Washington Public Power Supply System
A JOINT OPERATING AGENCY

February 13, 1981
G01-81-035

Subject: Washington Public Power Supply System
WPPSS Nuclear Projects Nos. 1 & 4
Diesel Engine Combustion Air Intake
And SRP 9.5.8

PROPOSED CHANGES TO DIESEL COMBUSTION AIR INTAKES

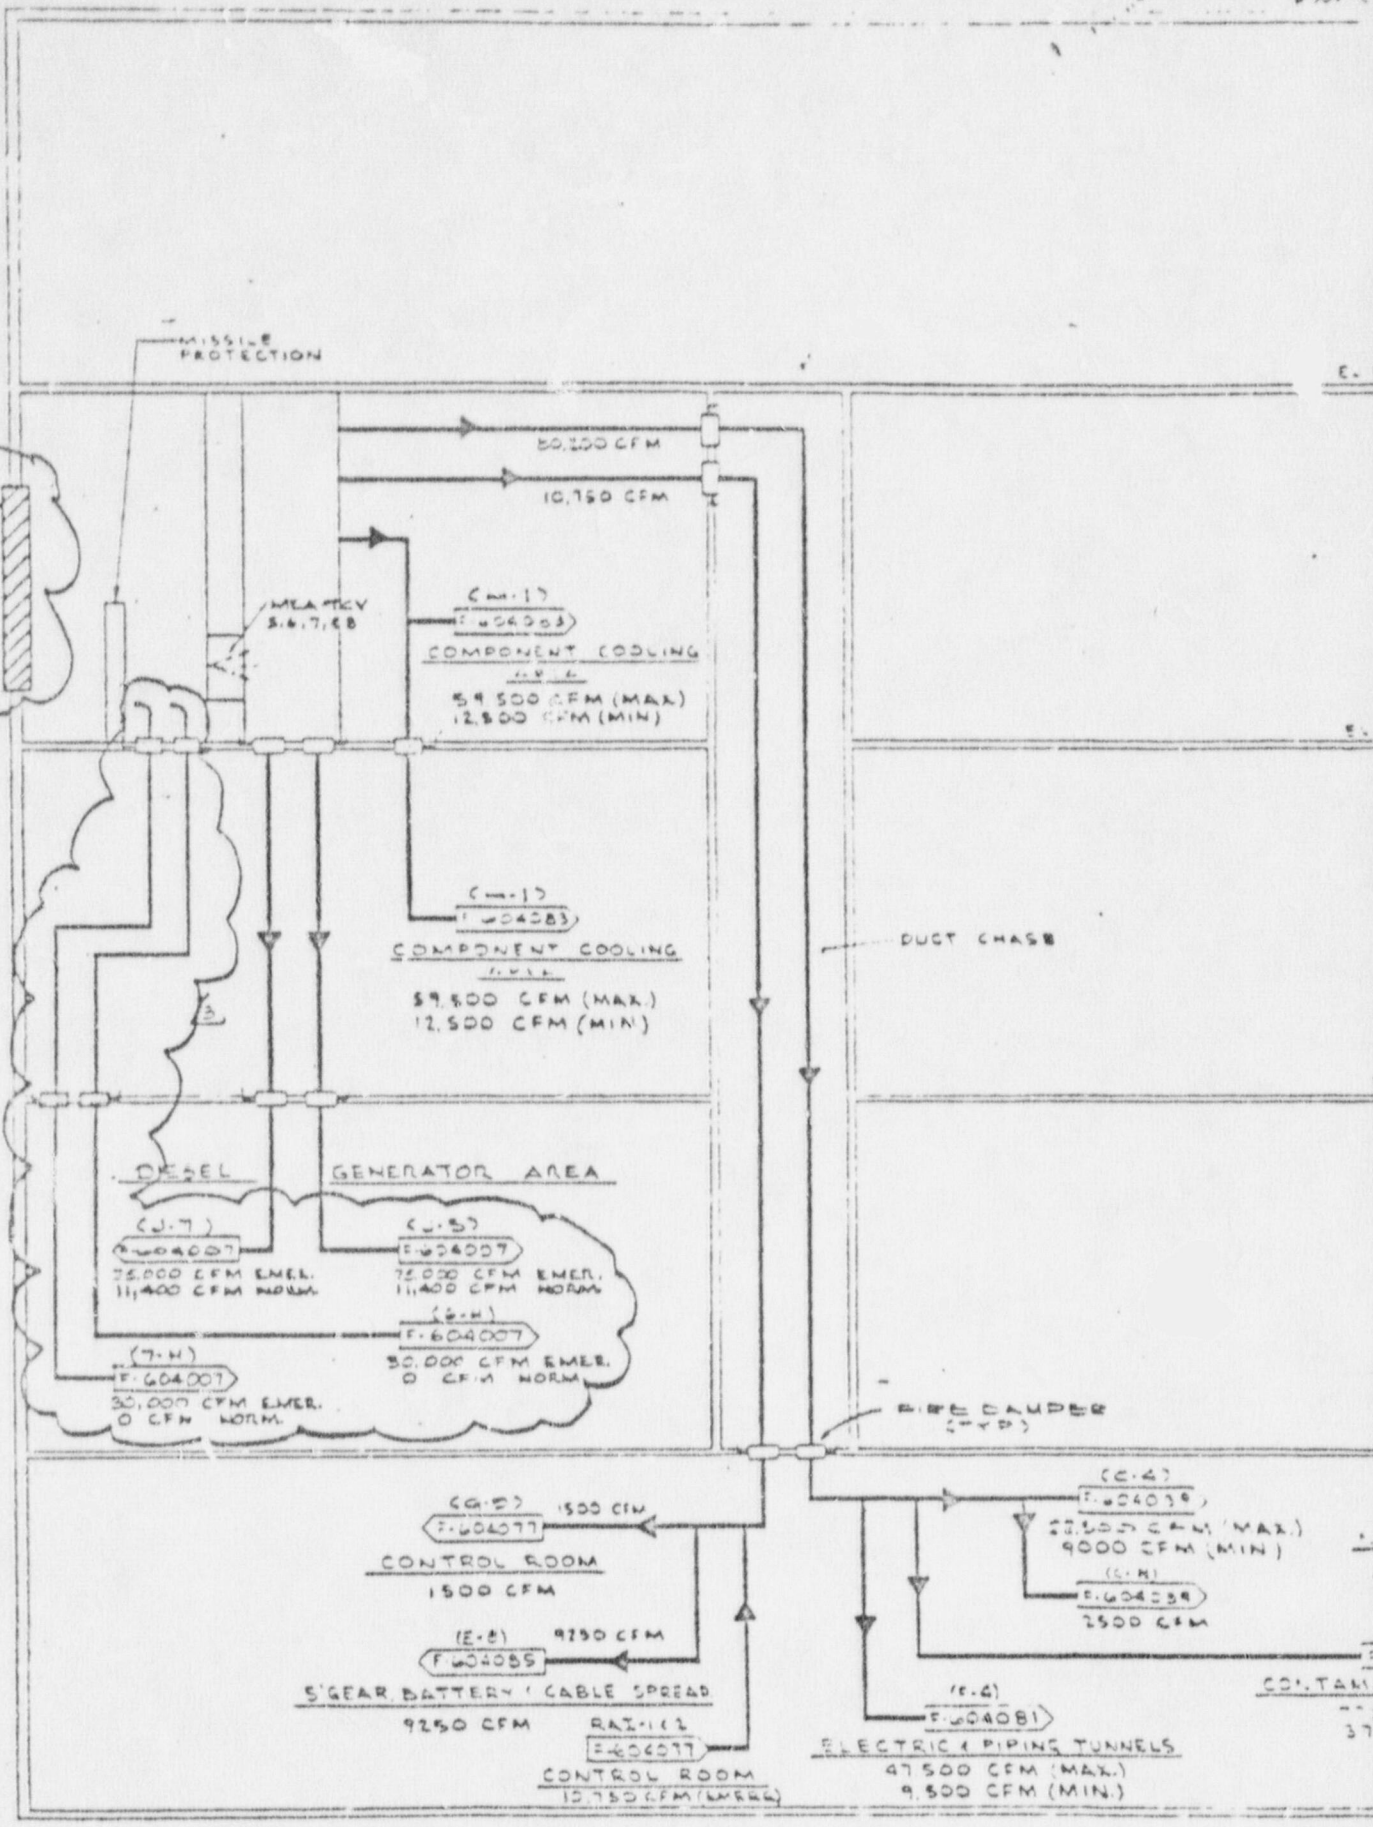
The WNP-1/4 design includes a common rather than a separate intake structure for the diesels. From this common structure separate ducts lead to each diesel. Within the common intake there are no active components servicing the diesels with the possible exception of redundant heat tracing on the intake louvers which may be added. These features are shown in the attached drawing.

The intake structure will withstand the effects of the Safe Shutdown Earthquake, the Operating Basis Earthquake, the Probable Maximum Flood, Tornado and Tornado generated missiles, as required by GDC 2. An evaluation of potential accidents which could occur in the vicinity of the site as required by SRP 2.2.3 has confirmed the acceptability of using a common intake.

As required by SRP 9.5.8, Item 8 of Section II, the Supply System has also taken the necessary design precautions to ensure that there is no plausible event that could reduce the oxygen content below acceptable levels at the common intake location.

On this basis the Supply System has determined that the use of a common diesel air intake structure is acceptable.

We would appreciate receiving NRC agreement with the use of a common intake structure for both diesel generators at WNP-1/4 by February 27, 1981.
